## **AMENDMENTS TO THE DRAWINGS**

FIG. 4

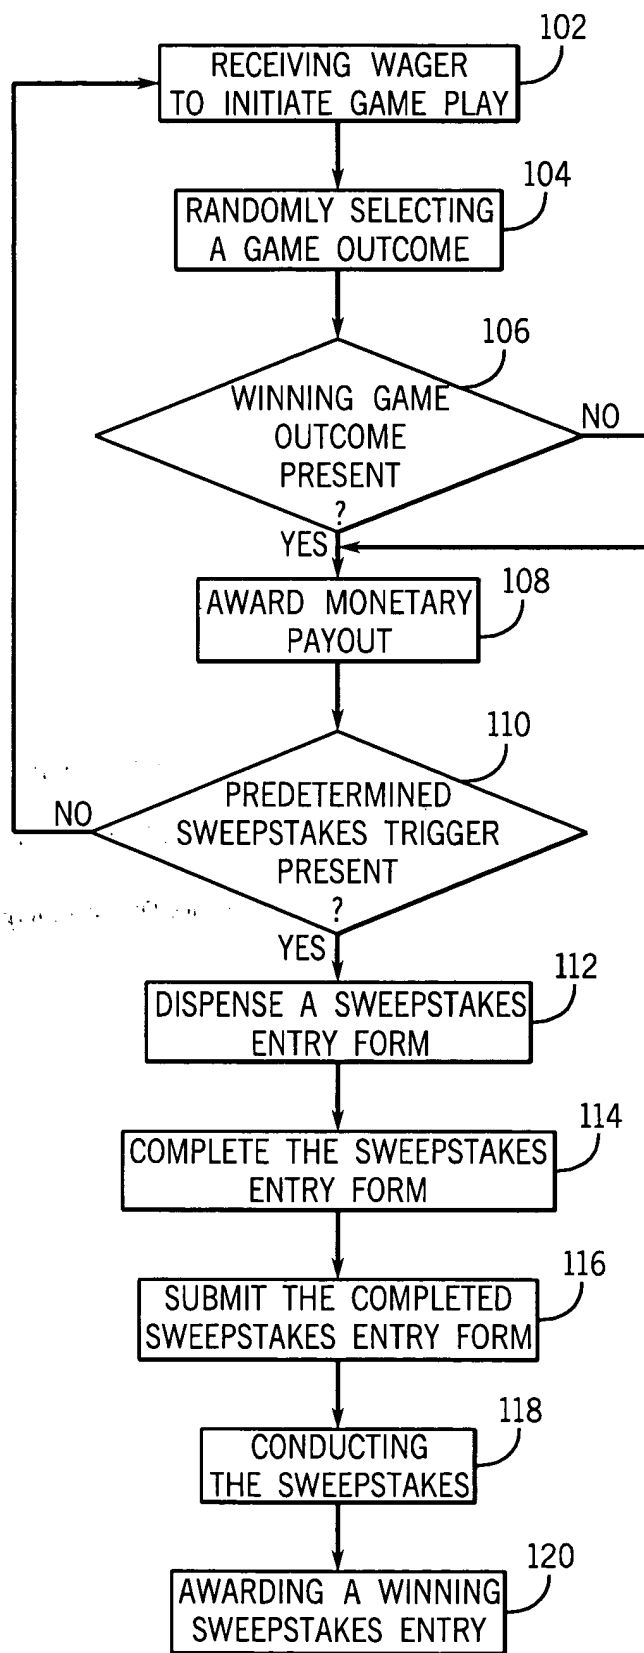
The drawings were objected to under 37 CFR 1.83 (a) on the basis that the drawings must show every feature of the invention specified in the claims. The Office Action further concluded that a block diagram showing the methods of claims 1, 3-4, 7, 14, 16, and 27-36 must be shown.

Applicant has drafted a figure of a block diagram containing each of the limitations described in the method claims (FIG. 4). This proposed drawing is being submitted to the Examiner for approval. Applicant believes that this drawing complies with the requirements of 37 CFR 1.83 (a) and overcomes the drawing objection.

OK TO ENTER  
5/5/04
